GENERAL APPLICATION

Explanation of Request: Site Plan approval to allow for the redevelopment of the Property to a mixed-use project consisting of 58-multifamily units and general office use.

Deandrea Moise, Planner
City of Hollywood
Department of Development Services

Thank you for reviewing this application for the Oak 58 (fka: Hollywood House) mixed-use project. Included in this memorandum, please find the applicant's response to staff's comments in **bold** text.

A2.0

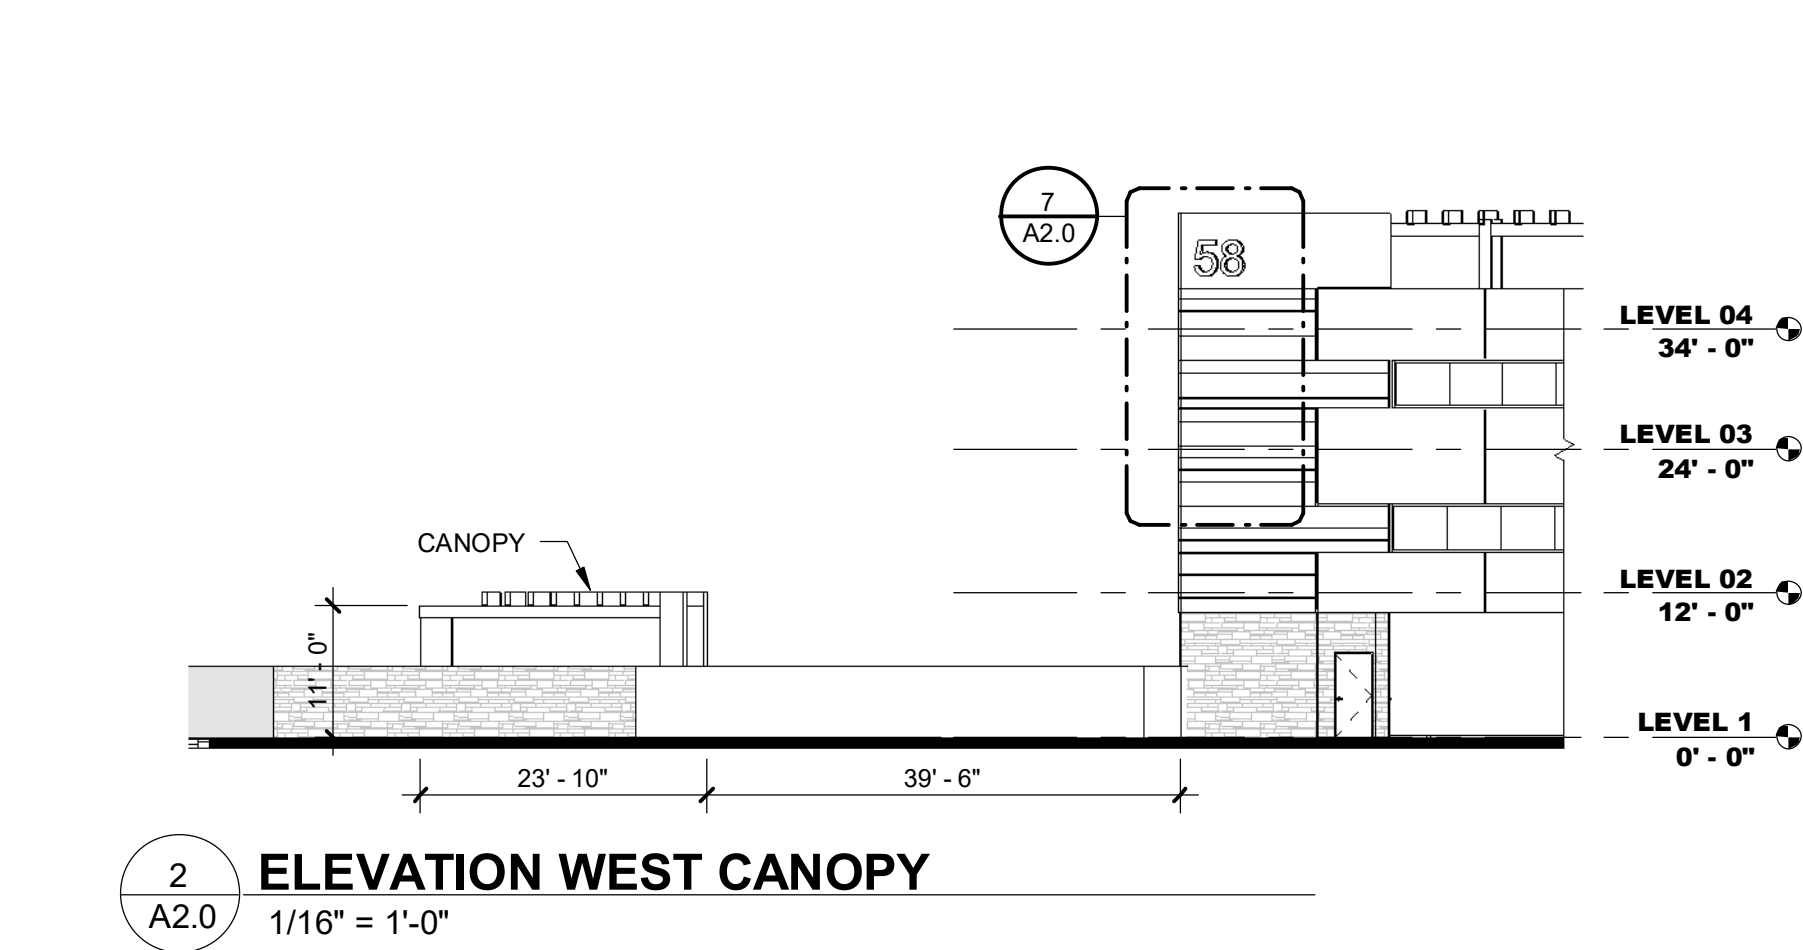
1. For review, full signage package shall be provided, including signage details, signs illustrated on Elevations, dimensions on Site Plan, etc.

Response: Please see sheets A1.1 and A2.0 for the proposed signage.
